Re: Initial Submission Review – Green Valley Ranch East Site Plan No. 18 - Site Plan and Plat
Application Number: **DA-1662-30**
Case Number(s): 2022-4023-00; 2022-3058-00

Initial Submission Review

GREEN VALLEY RANCH EAST SITE PLAN #18

DATE OF PREPARATION:	06-15-2022
SCALE:	1" = 30'
SHEET 4 OF 13

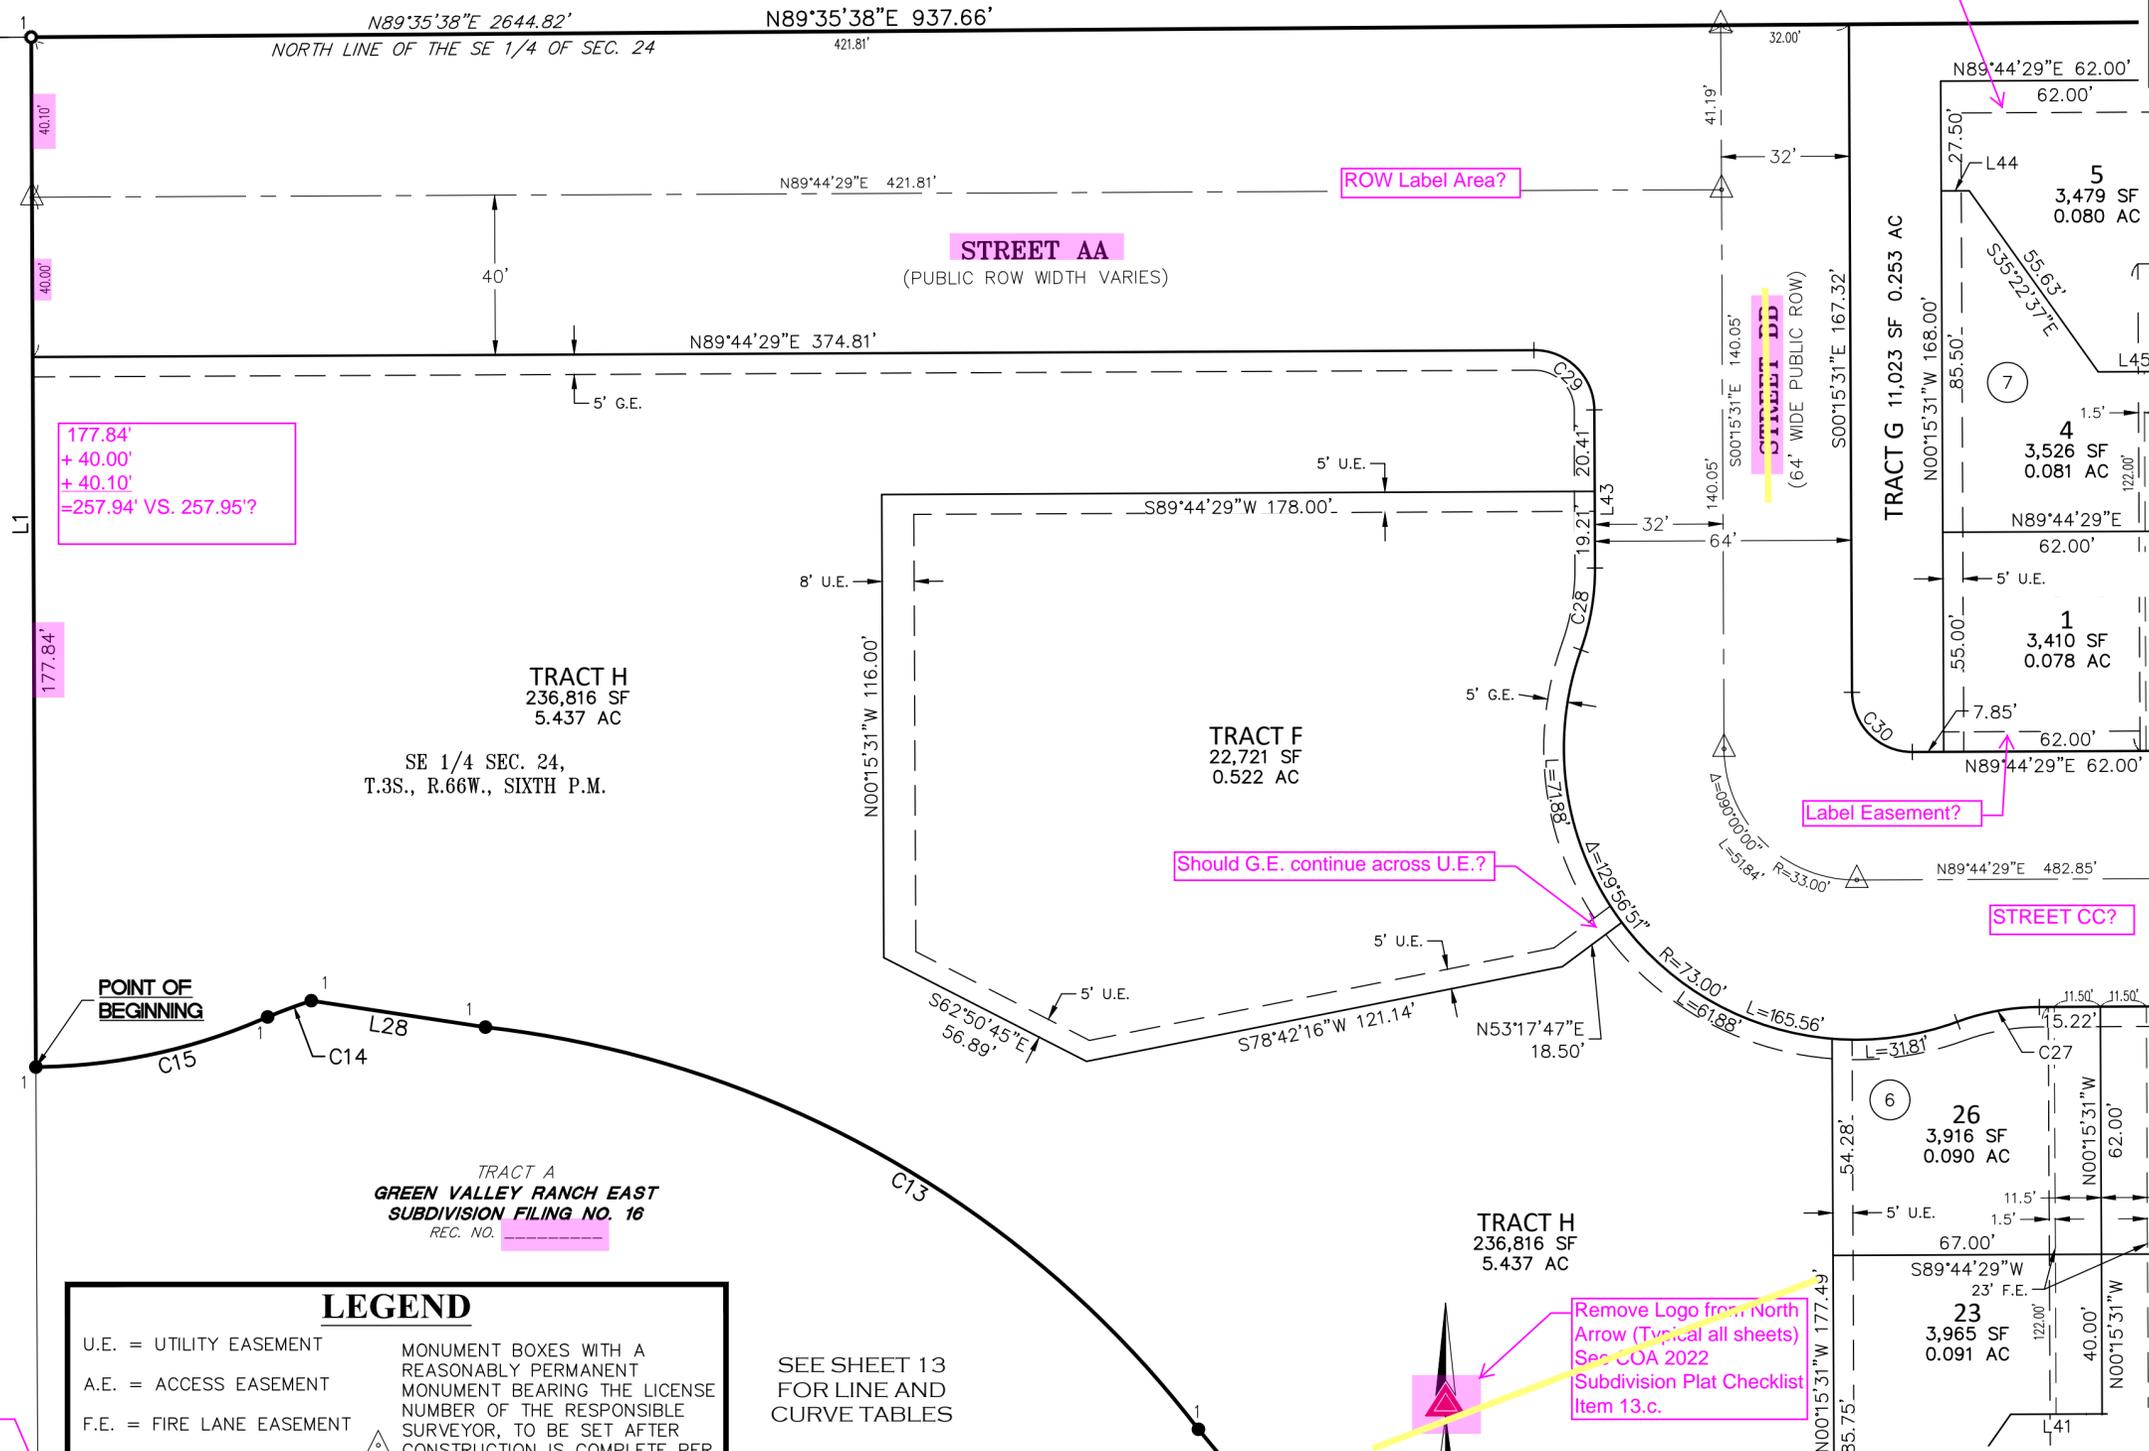
177.84'
+ 40.00'
+ 40.10'
=257.94' VS. 257.95'?

ROW width?
See Item # 13.a.

DATE OF PREPARATION:	06-15-2022
SCALE:	1" = 30'
SHEET 8 OF 13

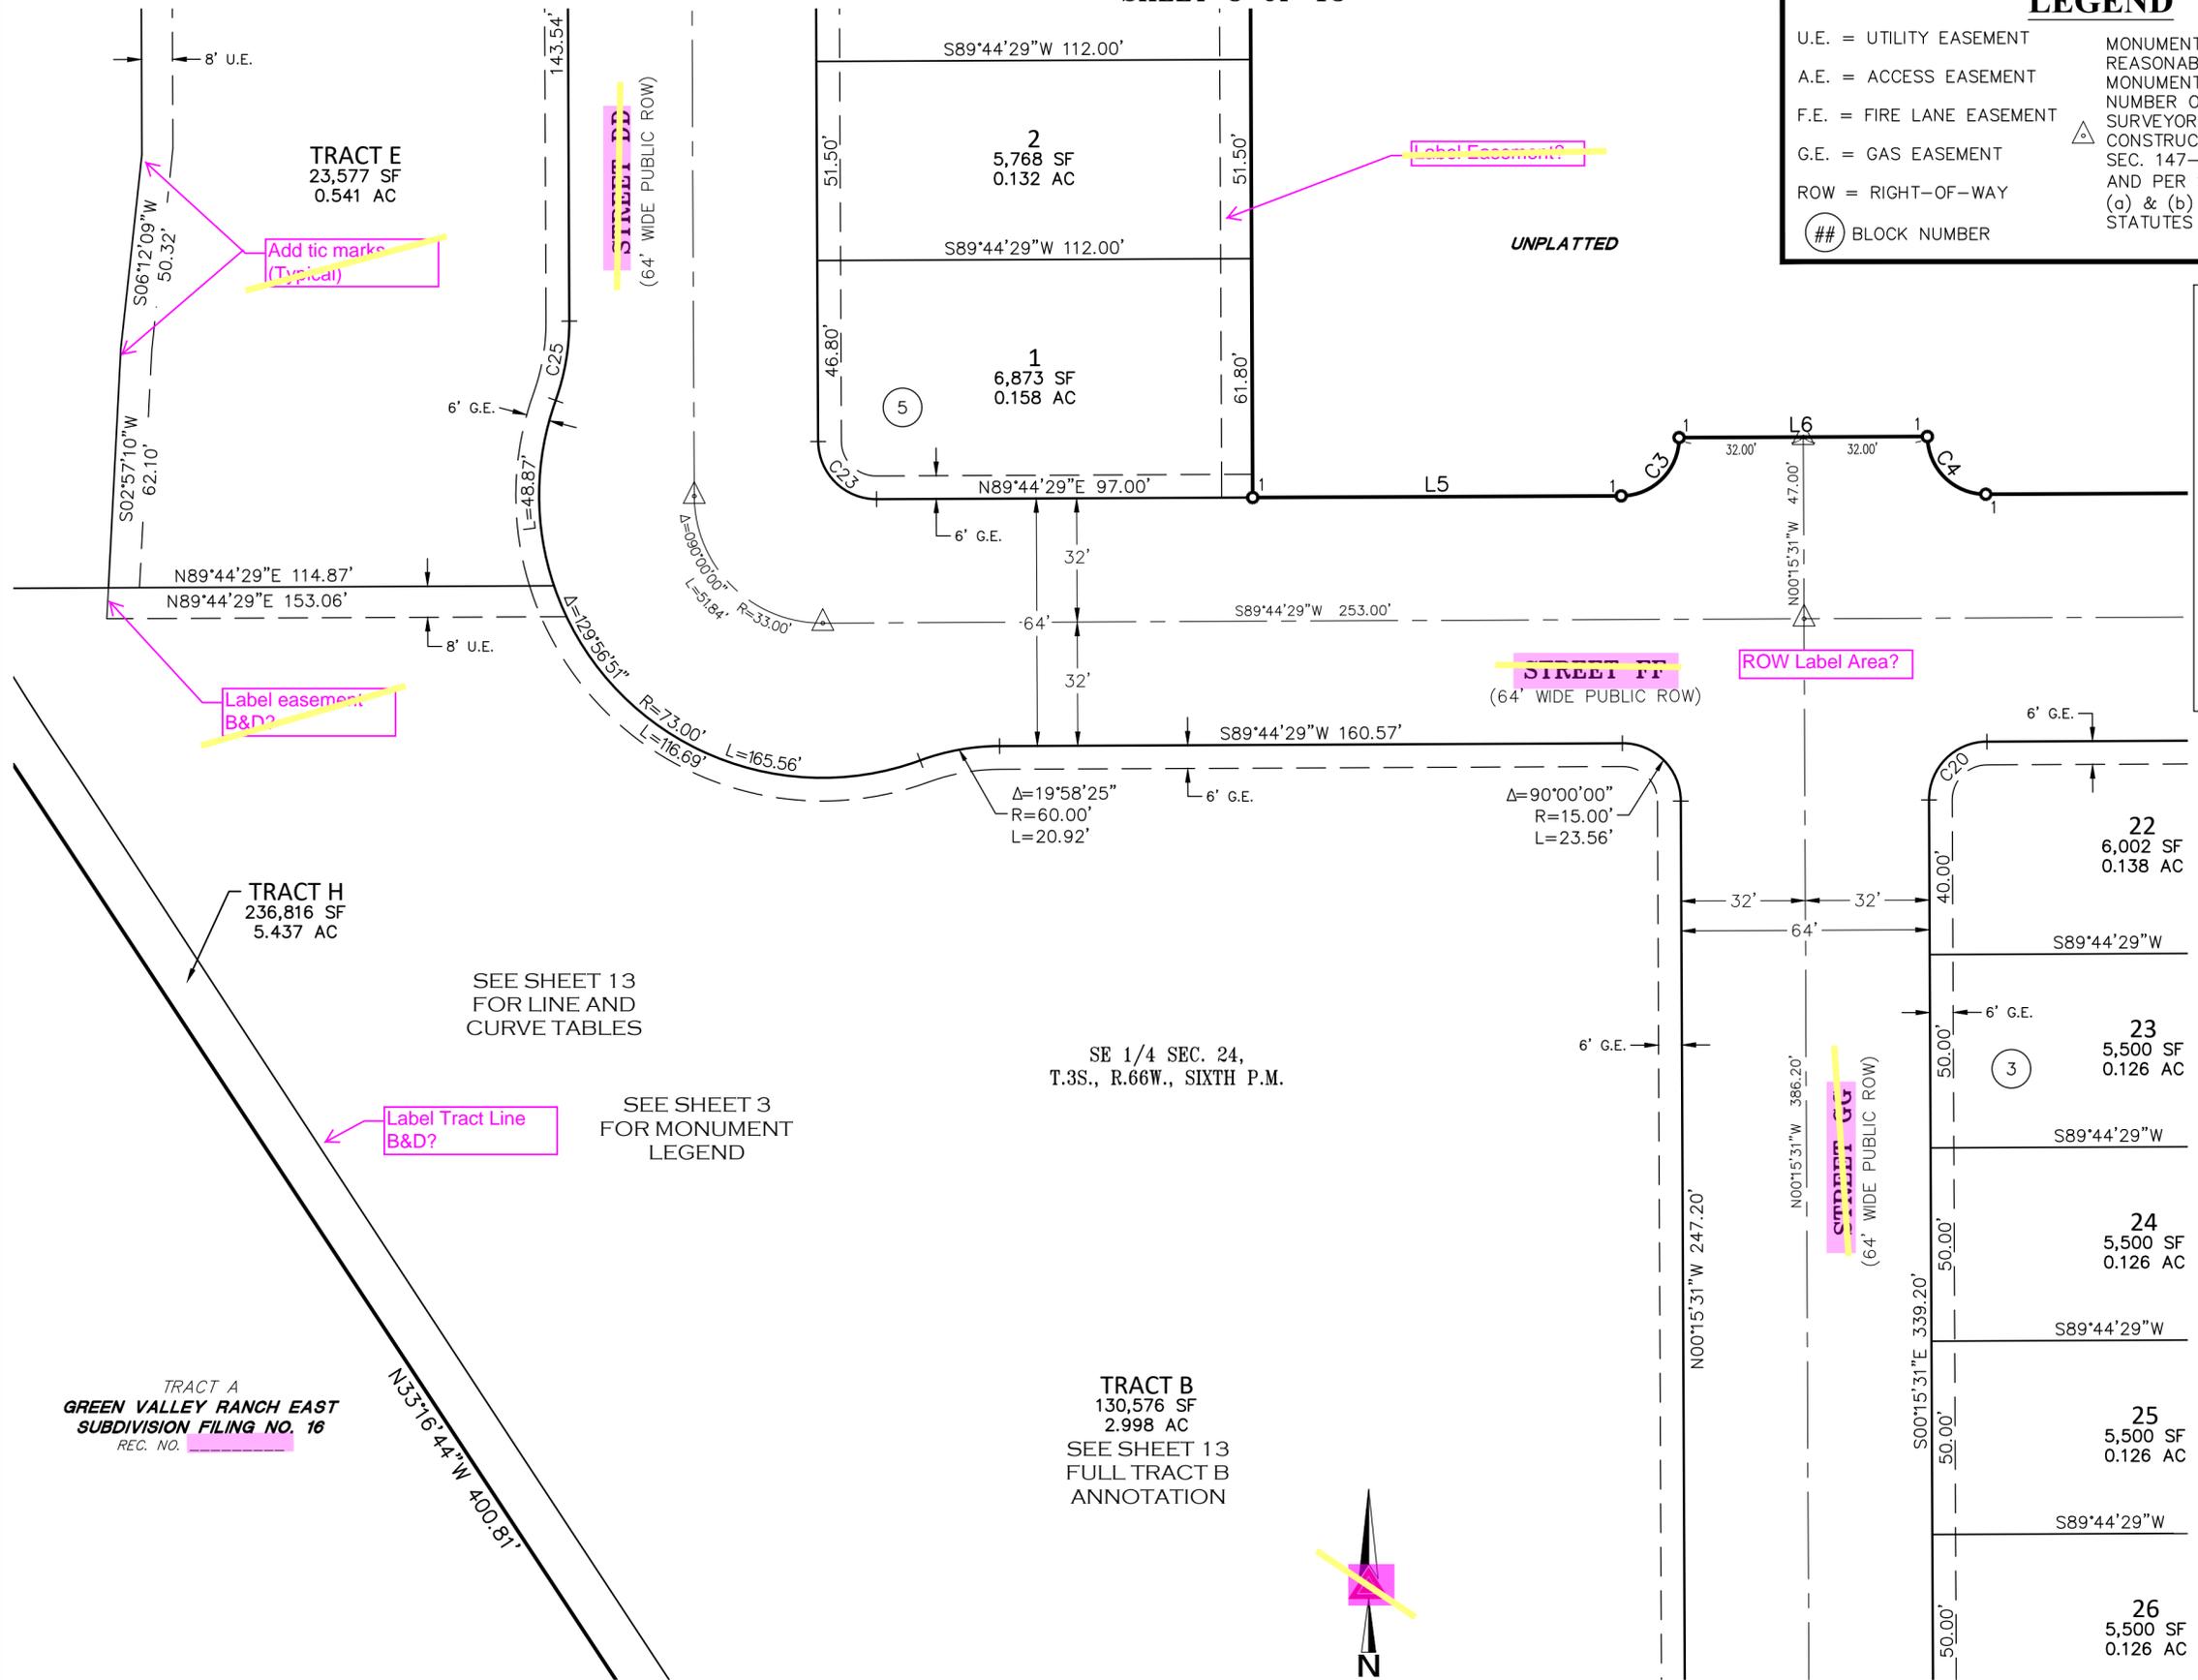
Add tic marks (Typical)

Label Easement?
